P.A. Air Force-99 Other Cust	International Intersect	AIR FORCE - NAVY AERONAUTICAL STANDARD	AN 6289
		NUT, TUBE	
Procurement Specification MIL-P-5509		SUPERSEDES: USAF DRAWING 46B1655	PAGE 1 OF 2

REVISED ⑦ 21 MAR 79
APPROVED 16 MAY 49

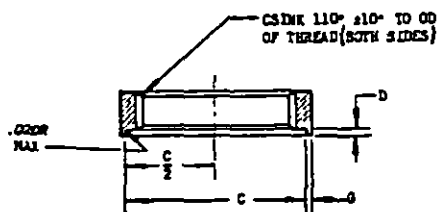
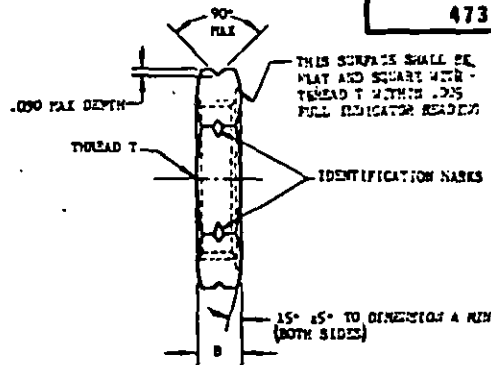
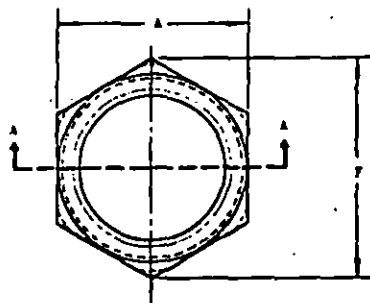
- ⑦ ADD D IN PLACE OF DASH FOR ALUMINUM ALLOY (EXCEPT 7075-T73).

~~ADD G IN PLACE OF DASH FOR CRES, TYPE 302, 303, 304, 316, AND 321.~~

- ⑦ ADD W IN PLACE OF DASH FOR 7075-T73 ALUMINUM ALLOY.

- ⑦ ITEMS CODED C ON PREVIOUS ISSUES OF THIS STANDARD ARE NO LONGER TO BE FURNISHED. PROCURING ACTIVITIES MUST SPECIFY APPLICABLE CRES MATERIAL CODE AS PART OF THE STANDARD PART NUMBER.

- ⑦ AN6289D8 - NUT, 1/2 TUBING, ALUMINUM ALLOY (EXCEPT 7075-T73).

~~AN6289G8 - NUT, 1/2 TUBING, CRES, TYPE 302, 303, 304, 316, OR 321.~~

- ⑦ AN6289W8 - NUT, 1/2 TUBING, 7075-T73 ALUMINUM ALLOY.
